## MAPA Meeting - November 1, 2022

### Recent and Upcoming Policy Changes (effective January 1, 2023 unless otherwise noted)

<b>MISSOURI HIGHWAYS AND TRANSPORTATION COMMISSION</b> 105 WEST CAPITOL JEFFERSON CITY, MO 65102 1-888-ASK-MODOT (1-888-275-6636)	
		<b>MIDWEST GUARDRAIL SYSTEM (MGS) SPECIAL INSTALLATIONS</b>
DATE EFFECTIVE: 01/01/2023 DATE PREPARED: 10/7/2022	<b>606.50E</b>	SHEET NO. <b>5 OF 8</b>

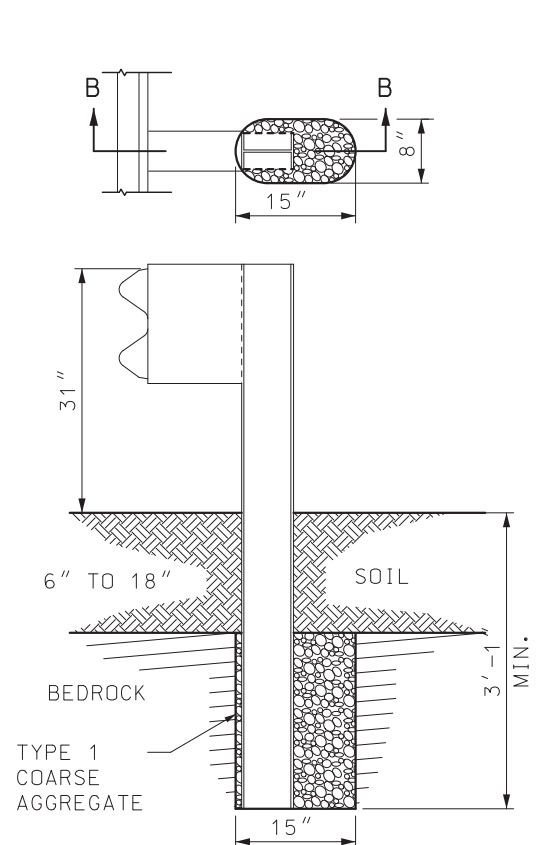
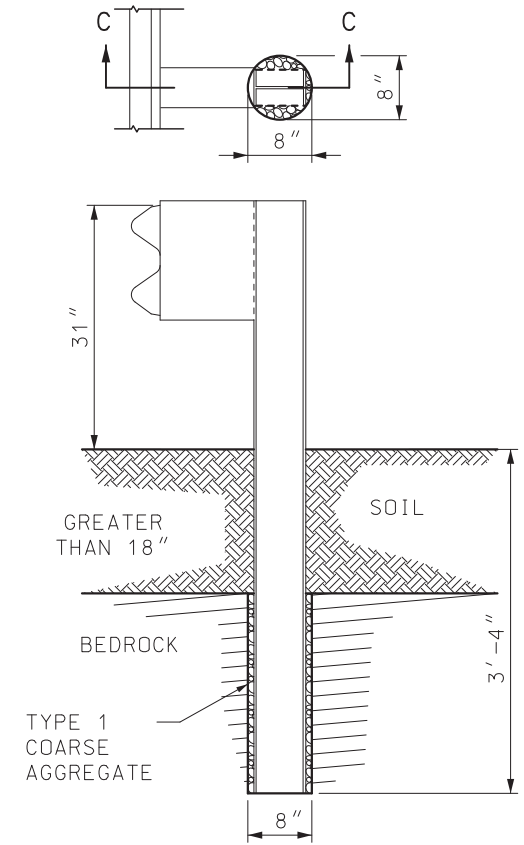
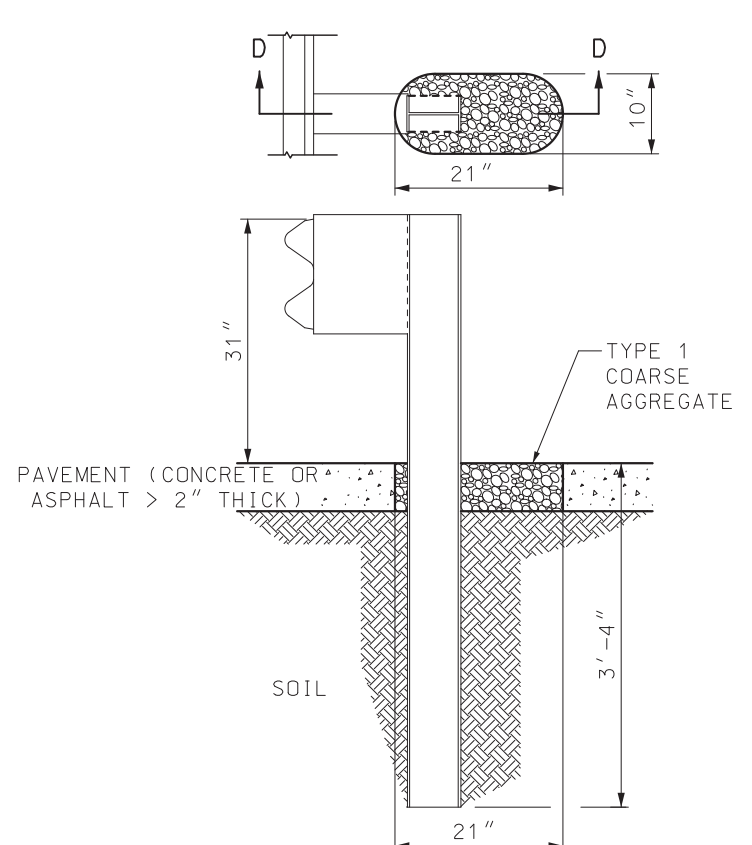
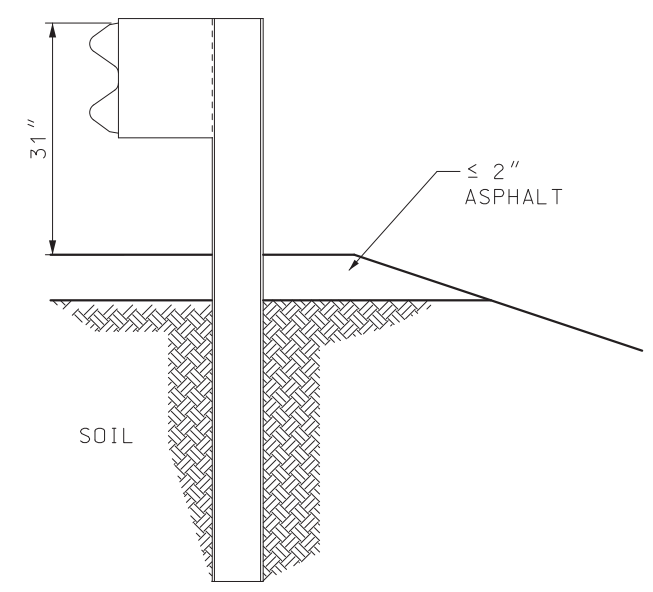
606.50 - Added a general note to state no additional payments will be made for cutting over-sized holes or placing aggregate material for guardrail posts.

NO ADDITIONAL PAYMENT WILL BE MADE FOR CUTTING THE OVERSIZED HOLES OR PLACING AGGREGATE IN THE HOLES, AS INDICATED IN THIS PLAN.

<b>MISSOURI HIGHWAYS AND TRANSPORTATION COMMISSION</b> 105 WEST CAPITOL JEFFERSON CITY, MO 65102 1-888-ASK-MODOT (1-888-275-6636)
	<b>TEMPORARY TRAFFIC CONTROL DEVICES SIGN MOUNTING REQUIREMENTS</b>
DATE EFFECTIVE: 01/01/2023 DATE PREPARED: 10/7/2022	<b>616.10BA</b>
	SHEET NO. <b>1 OF 9</b>

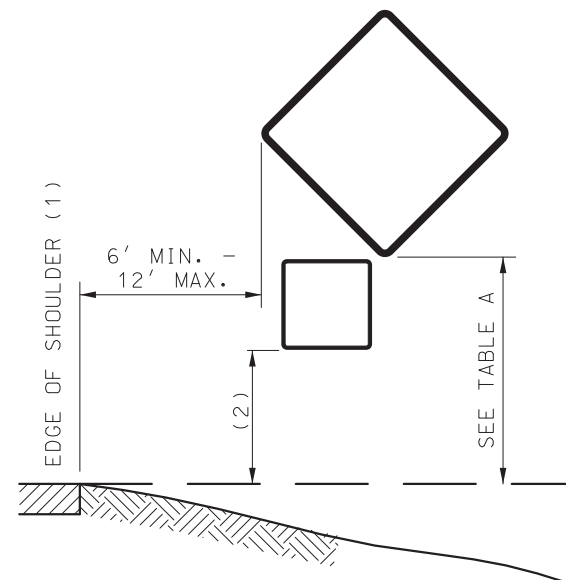
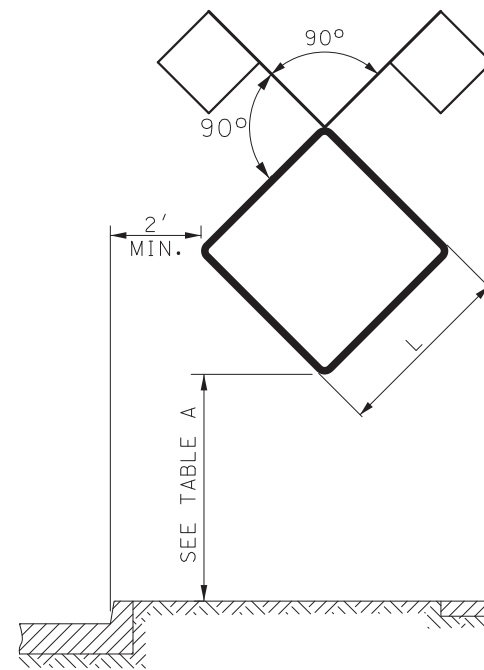
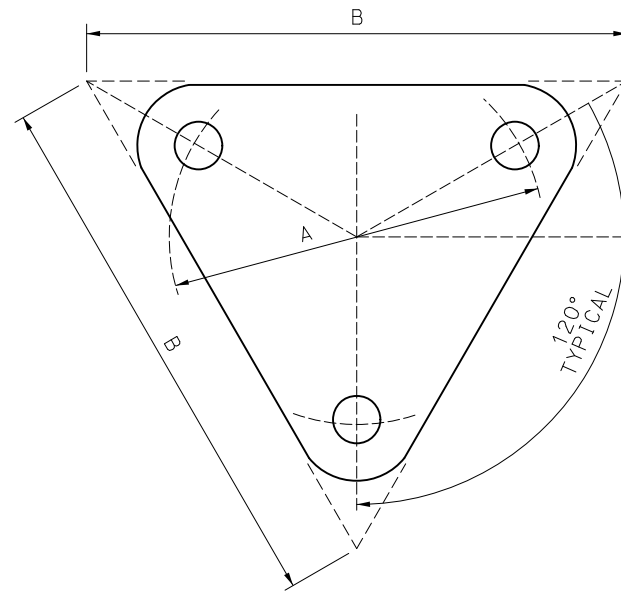
616.10 - In Table A Work Zone Sign Mounting Requirements, usage limitations have been updated for Type 2 portable signs. They can only be used for progressive work (ie. asphalt overlays), stationary work that will be completed in 3 days or less, or intermediate/discontinuous work that may exceed 3 days.

<b>MISSOURI HIGHWAYS AND TRANSPORTATION COMMISSION</b> 105 WEST CAPITOL JEFFERSON CITY, MO 65102 1-888-ASK-MODOT (1-888-275-6636)	
		<b>POST INSTALLATION DETAILS</b>  <b>PIPE POST</b>	
DATE EFFECTIVE:	07/01/2022	903.03BP	SHEET NO.
DATE PREPARED:	4/11/2022		5 OF 16

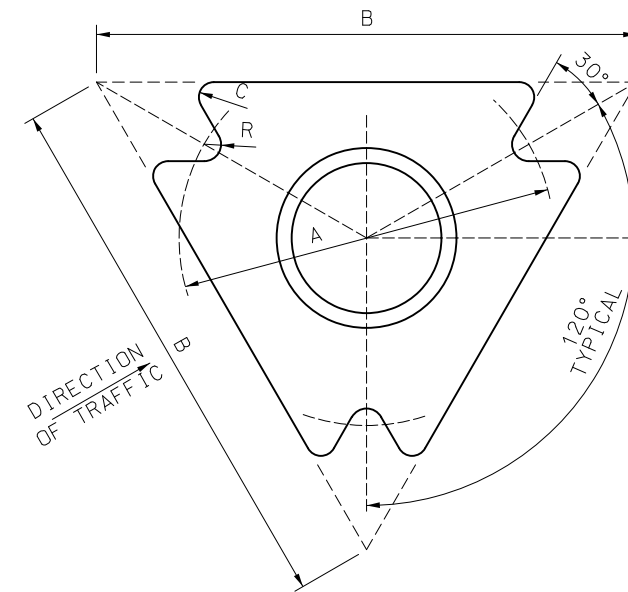
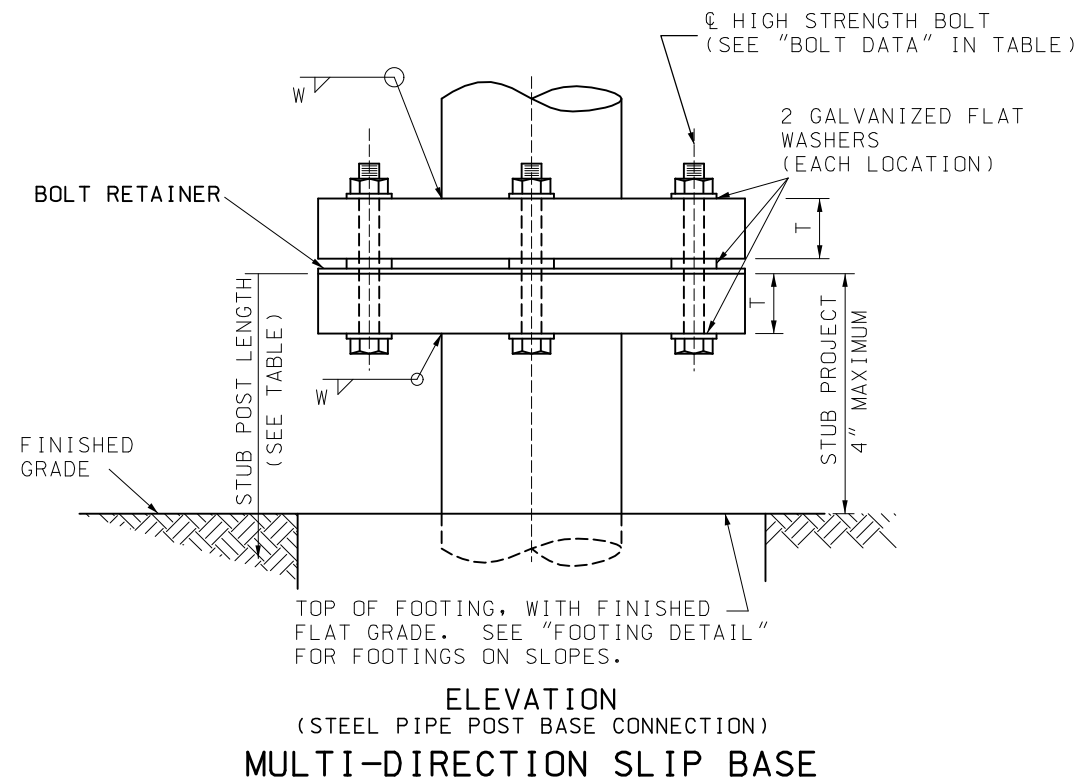
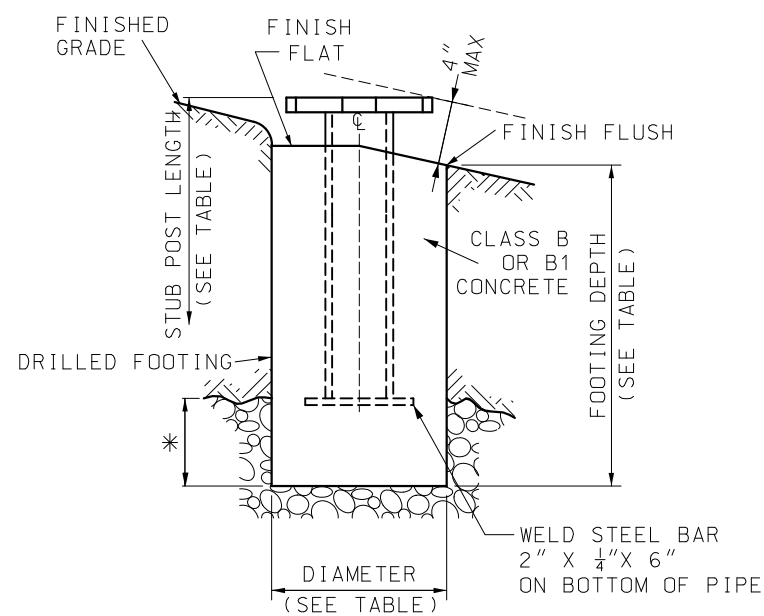
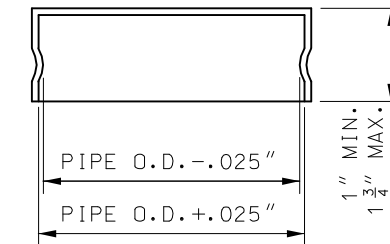
903.03 - 3" pipe posts are being discontinued due to 2.5" pipe posts being able to carry the same sign capacity/square footage.

ROUND PIPE POST FOR GROUND MOUNTED SIGNS												
POST NOM SIZE (IN. - ID)	BOLT			WASHER			BASE CONNECTION DATA TABLE (IN.)					
	DIA IN.	LENGTH IN.	TORQUE IN./LB.	OD IN.	ID IN.	THICK IN.	A	B	C	R	T	W
2 1/2	1/2	3 1/2	140	1 1/16	1 7/32	1/8	6 1/4	9	1/4	9/32	1	1/4
<del>3</del>	<del>1/2</del>	<del>3 1/2</del>	<del>140</del>	<del>1 1/16</del>	<del>1 7/32</del>	<del>1/8</del>	<del>6 1/4</del>	<del>9</del>	<del>1/4</del>	<del>9/32</del>	<del>1</del>	<del>1/4</del>
4	5/8	3 3/4	345	1 5/16	1 1/16	1/8	7 3/16	10	1/4	3/8	1	5/16

ROUND PIPE POST AND FOOTING DATA TABLE						
NOM. SIZE (IN.)	WEIGHT		STUB LENGTH	FOOTING		CONCRETE C.Y.
	LBS/FT	LBS/IN		DIA.	DEPTH	
2 1/2	5.79	0.48	4' - 3 1/2"	12"	4'-6"	0.13
<del>3</del>	<del>7.58</del>	<del>0.63</del>	<del>4' - 3 1/2"</del>	<del>12"</del>	<del>4'-6"</del>	<del>0.13</del>
4	10.79	0.90	5' - 3 1/2"	18"	5'-6"	0.36
